Second Request for Information Report

Rum Jungle Rehabilitation Project Stage 3 –
Environmental Impact Statement

Document title	Second Request for Information Report
Contact details	Department of Industry, Tourism and Trade
Approved by	J. Hartnett
Date approved	01/07/2022

Figure 1. Simulated and Estimated contaminate loads to the EBFR
 Note: Calculations informed by the RGC Goldsim Models.

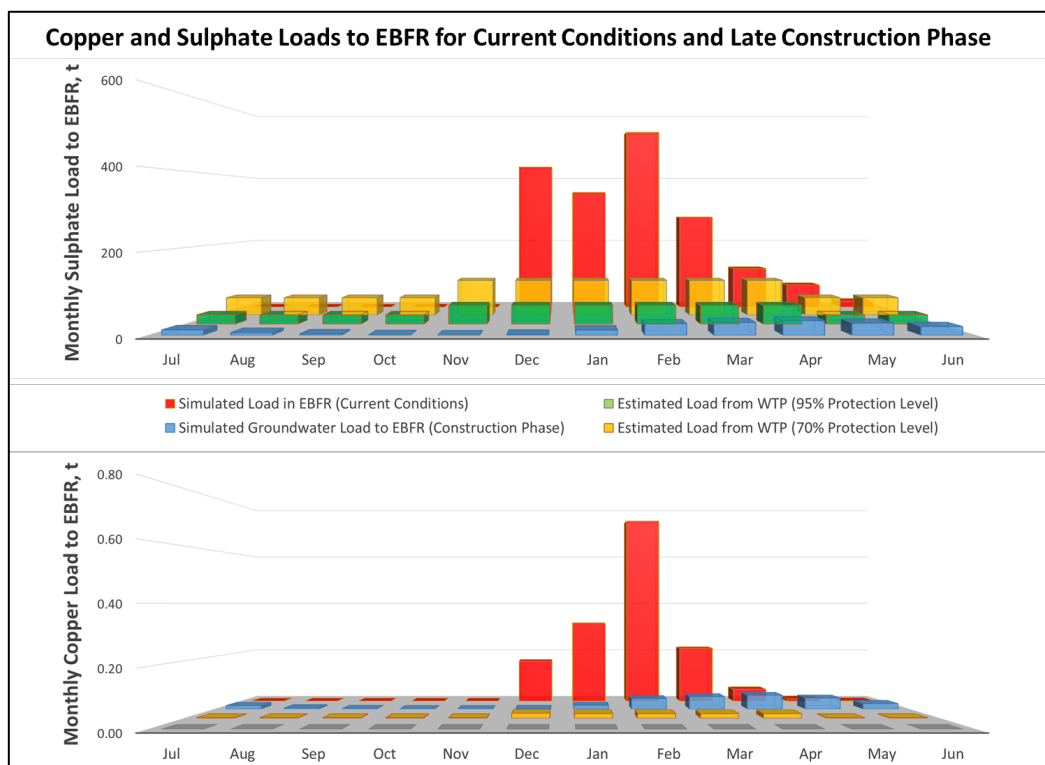
Ref. 3.2	
Comment	<p>Part 1) Appendix 19 of the Supplement (SLR 2020j) outlined the likely water treatment method used in the water treatment plant (WTP), including details of all chemicals used. However, the potential risks and impacts of these chemicals (e.g. flocculant Praestol 2540) and their breakdown products (e.g. environmental contamination from seepage if buried on site) were not addressed.</p> <p>(Part 2) Appendix 19 of the Supplement (SLR 2020j) introduces a recent water treatment technology, the Electrocoagulation MTECH Water, which produces 95% less sludge, requires no chemicals and would be powered by solar. This seems to have environmental benefits compared to the proposed WTP method. It is not clear why this alternative treatment method is not proposed and therefore what the considerations were, particularly in consideration of the waste management hierarchy.</p>
Further Information Requested	<ul style="list-style-type: none"> • Provide further information about the potential environmental risks and impacts of chemicals and their breakdown products used in the WTP. (NOT ADEQUATE) • Provide clarification and an outline of the considerations / analysis of the alternative water treatment options such as the Electrocoagulation MTECH Water WTP outlined in Appendix 19 to the Supplement, and justification for the proposed method. (NOT ADEQUATE)

Compared to the impacted groundwater reporting to the EBFR in its current uncontrolled state, treated water from the proposed WTP represents a significantly smaller overall contaminant load to the ecosystem, regardless of the WTP discharge criteria. Figure 1 illustrates the simulated and estimated loads to the EBFR for Copper and Sulphate under current conditions (less than 1% species protection), and with both 70% and 95% species protection as WTP discharge criteria. It is important to note that estimated loads include both treated water from the WTP and residual uncaptured waters reporting to the EBFR. The most significant reduction of impact to the environment can be seen in the capture of groundwater reporting to the system under current conditions (red columns) and the residual groundwater that would report to the system once the SIS program is operational (blue columns). Comparatively, there is significantly less improvement seen by increasing the discharge quality from 70% (yellow columns) to 95% (green columns).

Table 3 presents figures of the modelled contaminants loads under current conditions, at 70% and 95% species protection. While the jump from 70% to 95% WTP discharge only represents, overall, a small reduction in contaminant load reporting to the EBFR, it requires a substantial increase to operational costs, the implications of which are explored further below under Project Resources and Alternative Options.

Figure 4 RGC Waste Rock Dump PAF Characterisation Summary

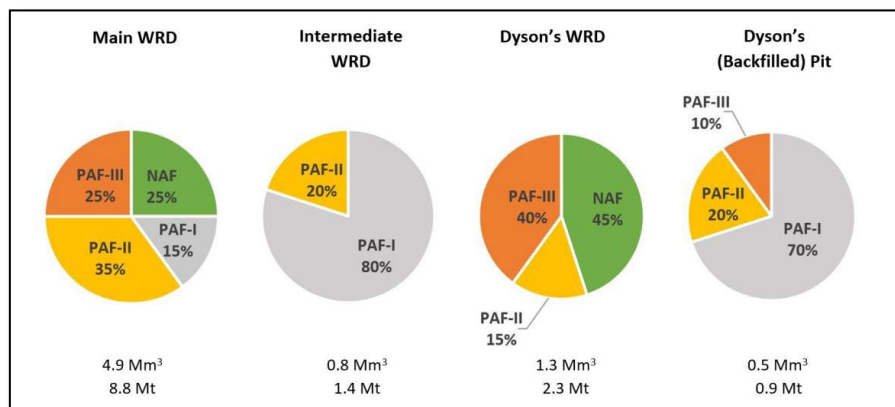
Ref. 3.7	
Comment	The Supplement indicated that materials would no longer be segregated at the deconstruction loading face.
Further Information Requested	<p>Clarify if PAF-I material would still be deposited in the Main Pit. (ADEQUATE)</p> <ul style="list-style-type: none"> If yes, provide information about a field validated segregation method, and associated quality assurance/quality control program for waste rock identification, segregation and management. (NOT ADEQUATE) If no, would less waste rock be deposited in the Main Pit? (N/A)
Adequacy of Response	<p>While the response clarifies the intent to store PAF-I in the main pit, it does not precisely conform to either option outlined in the request for further information.</p> <p>The response indicates that a no segregation will occur and that an adaptive approach will be taken by testing and applying lime to the pit. This leaves uncertainty as to the results that will be achieved.</p> <p>The response refers to section 3.3 of this report which does not appear to adequately describe how this approach will be successful.</p> <p>Section 7 of the draft EIS is also referenced however the details that adequately address the concerns of the request for further information are not specified.</p> <p>Given the importance of managing PAF-I material in the main pit, a more direct and thorough response is necessary. To properly understand the proponents plans to address relevant concerns and provide reassurance to the delegate, the relevant details should be extracted to explicitly address concerns.</p>

To reframe this Draft EIS statement, materials nominated for the backfill zone are segregated on a landform-scale basis. The following discussion describes the basis for this Project decision.

Core to the Project’s remediation action plan is the prioritisation of material by landform to be relocated to the Main Pit backfill based on risk of AMD production posed by PAF material. Previous work done by RGC and summarised in the 2019 *Rum Jungle Physical and Geochemical Characteristics of Waste Rock and Contaminated Materials* report has enabled the Department to make the informed decision to segregate waste rock by facility and **place all waste rock material** from the Intermediate WRD and Dysons Backfilled Pit into the Main Pit. Figure 1 shows that the vast majority of these two facilities are PAF-I and PAF-II.

Figure 5. Settlement Plate/Rod for Monitoring (Geometrik 2022).

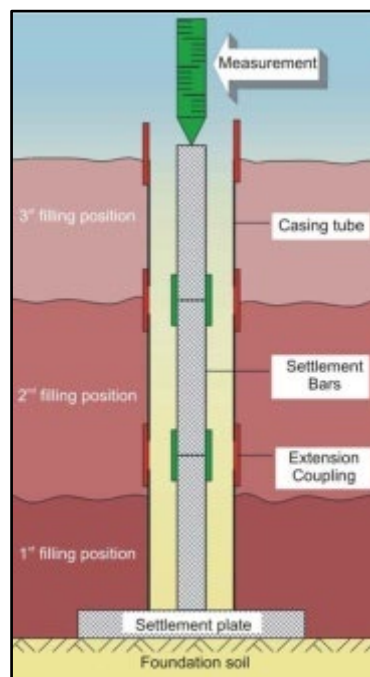
Ref. 3.8	
Comment	<p>The River Reinstatement and Flooding Report (Appendix 17 of Supplement), and design drawings for the Main Pit and Reinstatement of the EBFR (Appendix 24) indicate that the dry season Top Water Level of the Main Pit post-rehabilitation will be 1m over the capping layer.</p> <p>This is contrary to statements in the supplement that the minimum depth would be 2 m above the capping layer.</p> <p>The Draft EIS and Supplement state that this water level was estimated based on current groundwater levels.</p> <p>The depth of water over the backfilled waste rock in the Main Pit is essential information for the NT EPA to consider since the water cover is a critical element of the rehabilitation to prevent oxidisation of stored waste rock.</p> <p>For the Supplement, the NT EPA requested that worst case scenarios of climate change impacts be taken into account. This should include not only extremes of high rainfall, but also extremes of low rainfall, falling groundwater levels and increased evaporation.</p> <p>The Proponent needs to consider the potential effects of these extremes on water levels in the Main Pit.</p> <p>The Proponent states that there will be settlement within the Main Pit once it has been capped (Appendix 17 of Supplement). If settlement is uneven, this could result in ripples or dips, leading to altered rates of erosion to the surface.</p>

The instillation of anchored rods into the waste rock, analogous to a settlement plate, will enable the Project to monitor high risk zones of the Main Pit capping as identified by the Climate Change Assessment (appendix 4). The installed settlement bars will move with the waste rock and depth markings will enable the relative thickness of the capping layer to be monitored throughout the wet season and following high flow or flood events. Evidence of erosion would then trigger corrective actions to repair and reinforce areas that have been susceptible to erosion. Corrective actions would be in the form of capping “top ups” and rock armouring to minimise ongoing erosion. Geophysical surveys such as ground penetrating radar would be triggered if multiple points of erosion activity is identified and used to inform corrective actions. An example of an in-situ settlement plate/rod can be found below at Figure 5, please note that although the below example includes casing around the rod the Project would not include this element to reduce the risk of contaminant movement pathways and oxidisation occurring within the waste rock.

The Project has included these measures in the EMP Stabilisation Monitoring Plan and Trigger Action Response Plan and supporting management plans as appropriate.

Figure 6. Dry season dissolved copper concentration trends and variability by Finniss River Zone.

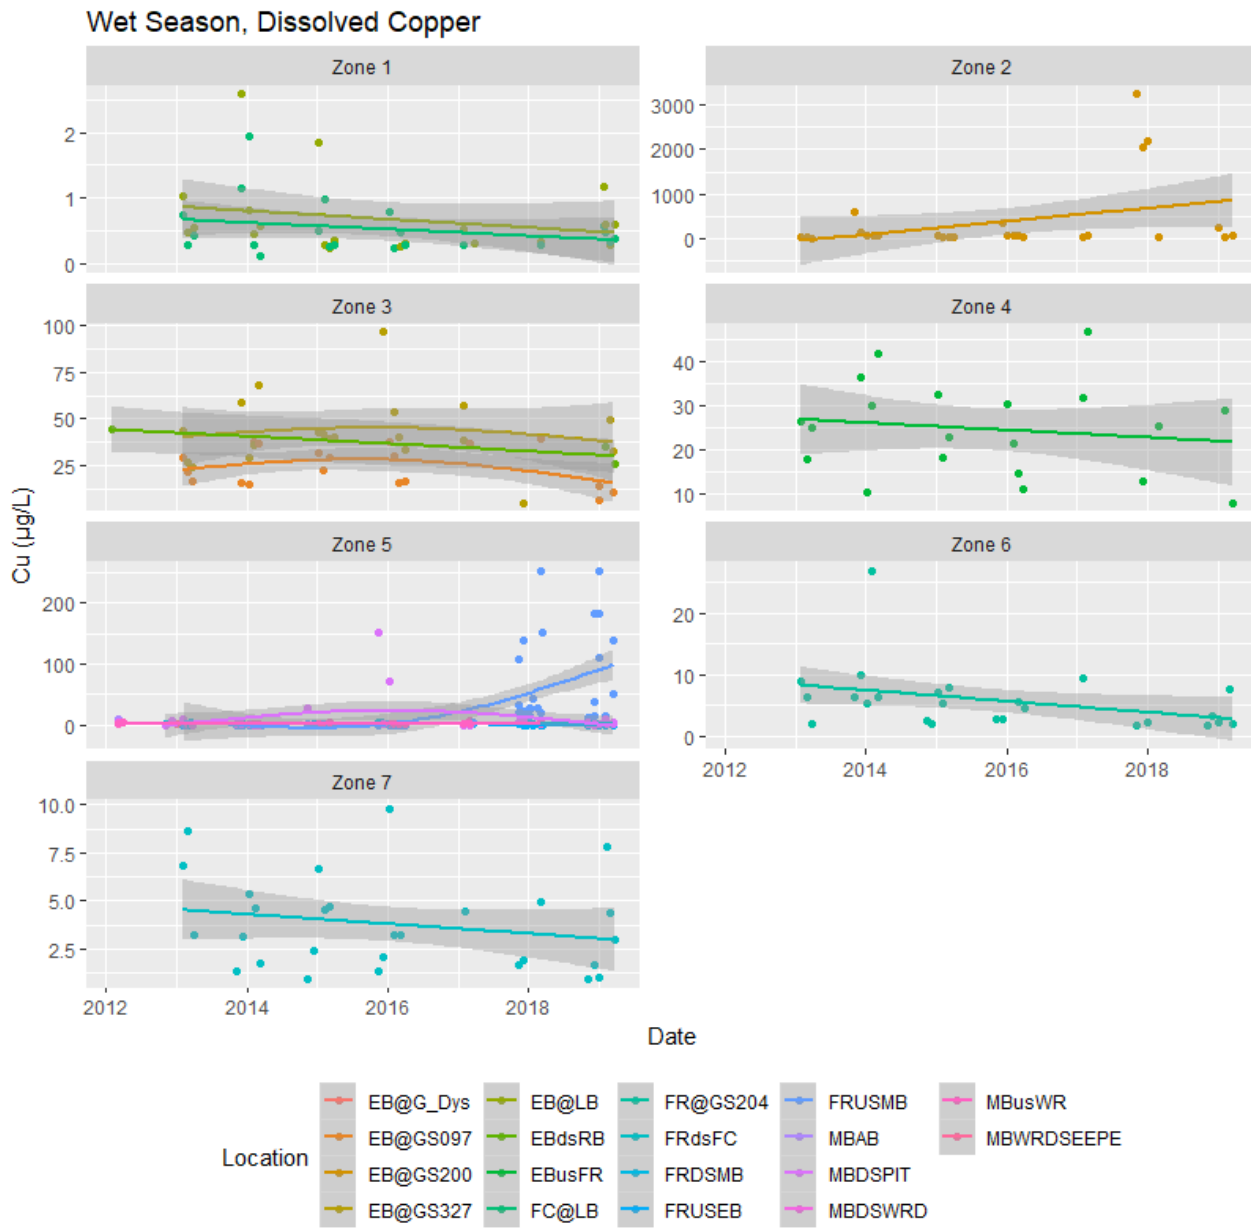
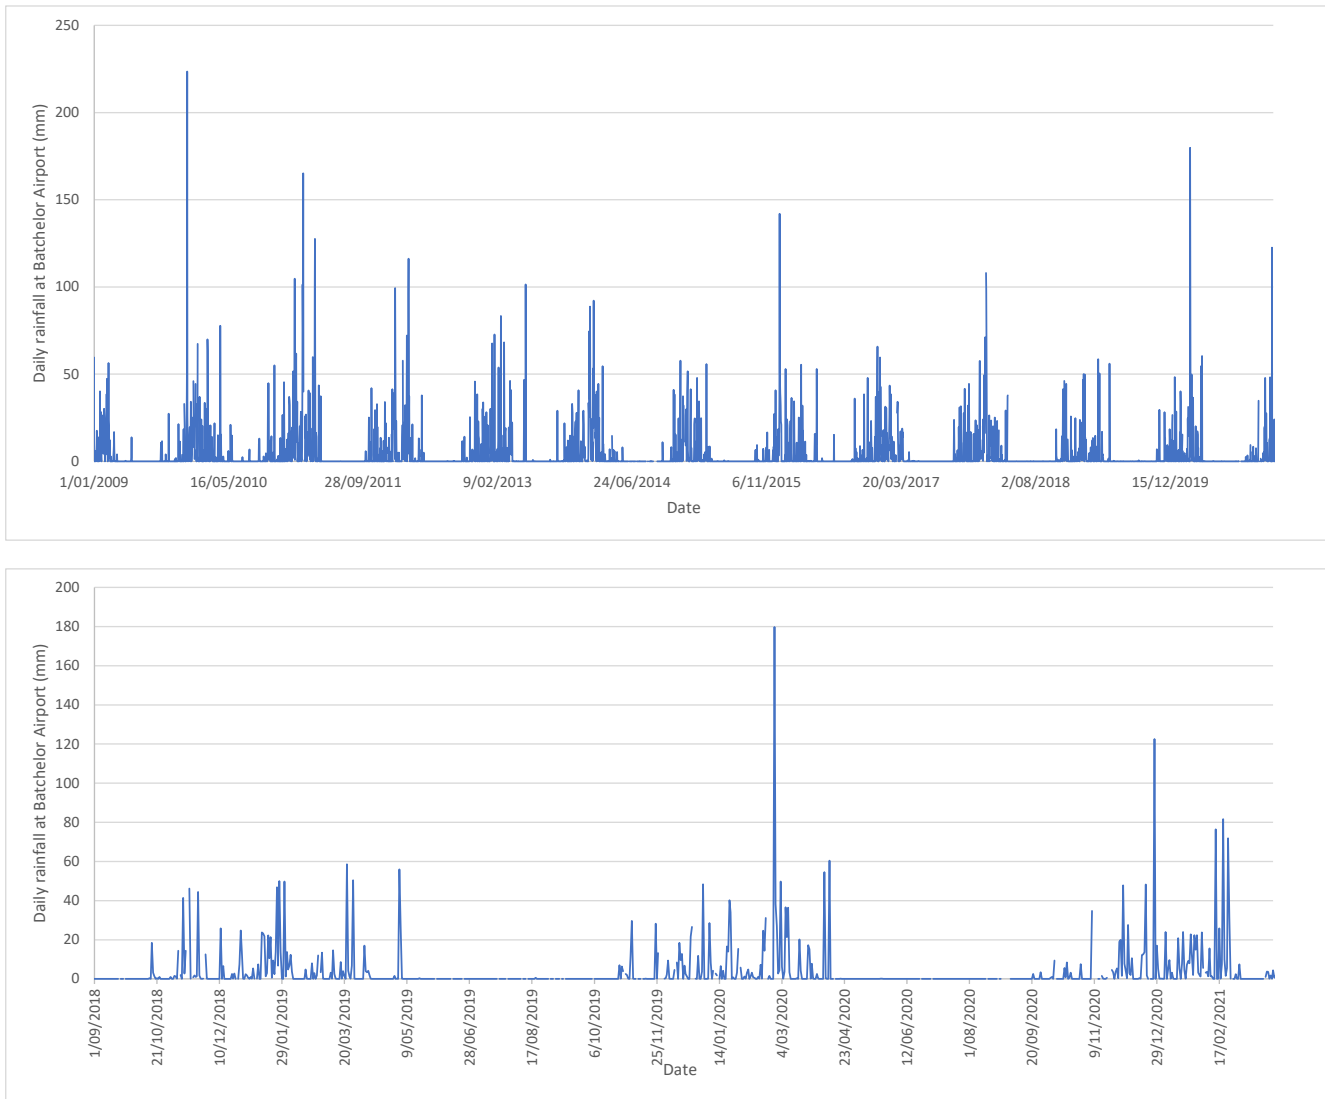
Adequacy of Response	<p>The Department notes that the requested information was either not provided or only partially provided. To fill this gap, please provide:</p> <ul style="list-style-type: none"> - Summary tables for zones 8 and 9 of the Finniss River, in addition to the previously supplied information. - summaries of groundwater data, grouped by aquifer and impact/non impact locations, depending on data availability, as previously requested. Groundwater monitoring data should include the full suite of analytes, including but not limited to metals and the metalloids arsenic and selenium.

Firstly, it is reasonable to conclude, as DAWE has, that for many parameters there have not been strong temporal trends but there has been high variability. For example, the Figure 6 and Figure 7 plots for copper are from (Hydrobiology, 2020). While there are some trends within a season and a zone, there is little consistency in the trends between zones, even within the East Branch, and the trends appear to be strongly influenced by variability. Note that as these are left-censored data, increasing variability will tend to result in positive trends, even if the true mean does not change, but also that statistical analysis of the influence of low-frequency high concentrations has not been undertaken. For example, the apparent trends for Zones 2 and 7 in the dry season and zones 2 and 5 in the wet season were due to higher variability in the 2017 and 2018 datasets.

Figure 9. Wind roses at Project Site - figure 3-2 of GHD (2019a).

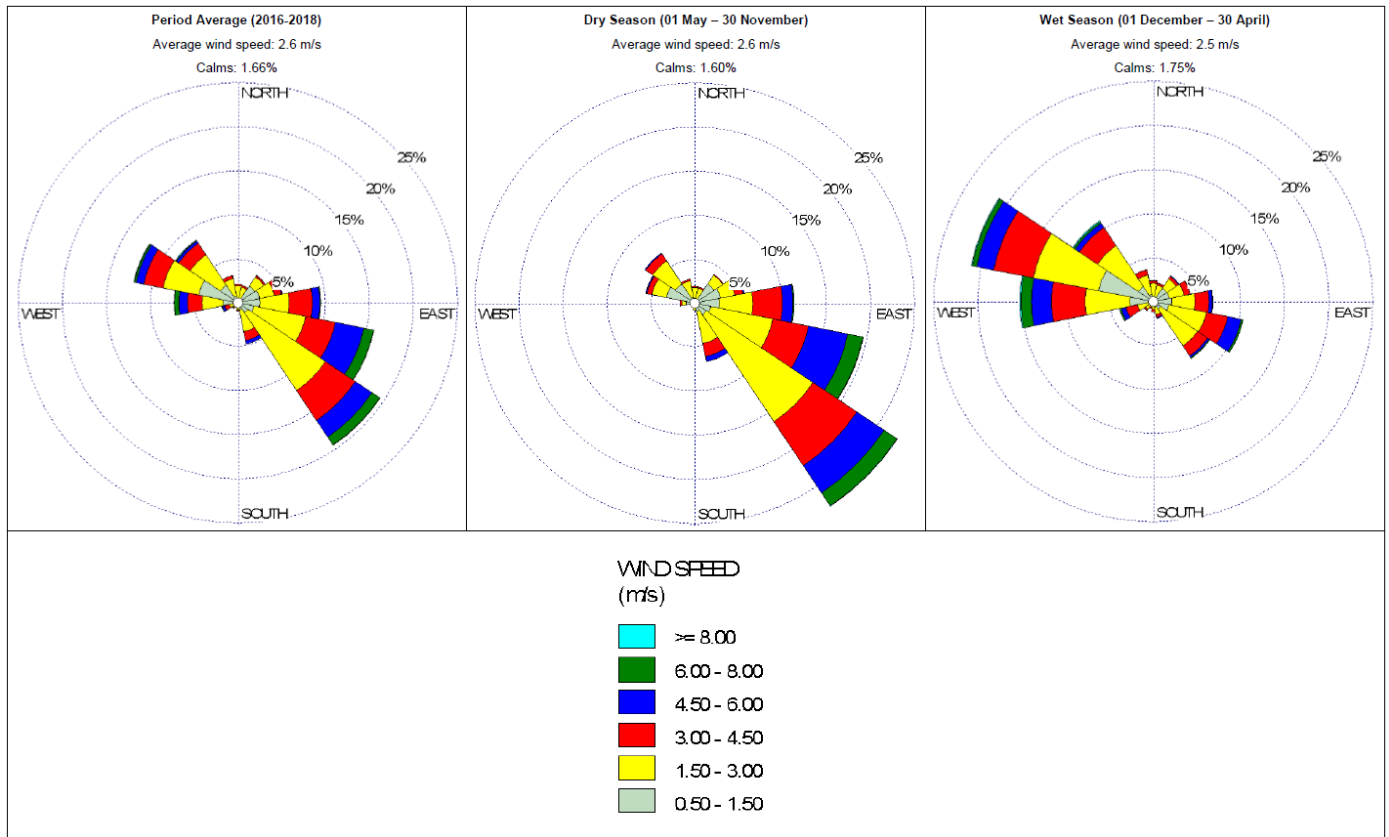
Adequacy of Response	<ul style="list-style-type: none"> • The response states that the identified sensitive receptors are the closest to the project from an air quality impact perspective, however, the reasoning is not explained. Instead, references to existing documentation are provided. Please provide a clearer, and more direct, explanation for the discrepancy in sensitive receptor locations. • Future Air and Dust Management Plans as well as Stakeholder Communication Engagement Strategy have been committed to. The Department considers that, if

With the consideration of local climatic and wind conditions (Figure 9) the receptor is likely to receive moderate exceedances of the maximum cumulative PM_{10} and/or $\text{PM}_{2.5}$ concentration objective by more than 10 $\mu\text{g}/\text{m}^3$ for more than one month but is unlikely to exceed them for most months. Due to the nature of the exceedance mitigation measure will be necessary to protect human health. Recommended mitigation measures adopted by the Proponent will include a combination of:
